Re: Minor Project Refinement No. 3 for the South Orange County Reliability Enhancement Project.

South Orange County Reliability Enhancement Project CPUC Minor Project Refinement Form

Date Requested: June 20, 2019

Report No.: 3

**MPR-3 FIGURE 1
SAN JUAN CAPISTRANO SUBSTATION**

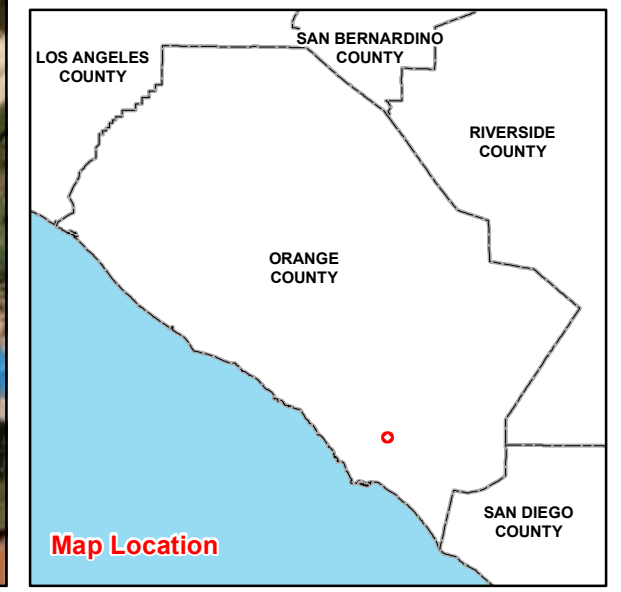
San Diego Gas and Electric (SDG&E) is requesting approval of MPR-3 for new temporary work areas in San Juan Capistrano's Long Park required to facilitate construction activities approved under Notice to Proceed No. 4 (NTP-4) for the South Orange County Reliability Enhancement Project (SOCRE or Project). The new temporary work areas will extend from the north and south borders of the temporary workspace previously approved in NTP-4 in Long Park and public ROW. The northern workspace will extend approximately 100 feet from the north border of the NTP-4 workspace (totaling 4,000 square feet), and the southern workspace will extend approximately 300 feet from the south border (totaling 11,300 square feet). Both areas will span

the width of Long Park from Camino Capistrano to the western terminus of the park near the railroad. Combined, the new MPR-3 work areas will total approximately 15,300 square feet (0.35 acre).

Work within the MPR-3 areas is scheduled to begin immediately after SDG&E secures the necessary permits from the City and all other pre-construction conditions are met. **Attachment B, MPR-3 Figure** shows the location of the MPR-3 temporary work areas.

Maps & Figures: Refer to **Attachment B, MPR-3 Figure**, for a map of the proposed MPR-3 temporary work area locations. Refer to **Attachment C, MPR-3 Site Photographs**, for pictures

COA-1. MPR-3 Temporary Work Areas will be limited to the areas shown on MPR-3 Figure 1 and will be used for construction staging and related activities only during the period of construction and restoration associated with approved NTP-4 construction activities.

COA-4. The large *ficus* tree near the center of the south Temporary Work Area will remain and be protected throughout the period of use of the Temporary Work Areas. Orange plastic fencing or similar protective fencing will be placed around the drip line of the tree to identify the protected area around the tree.
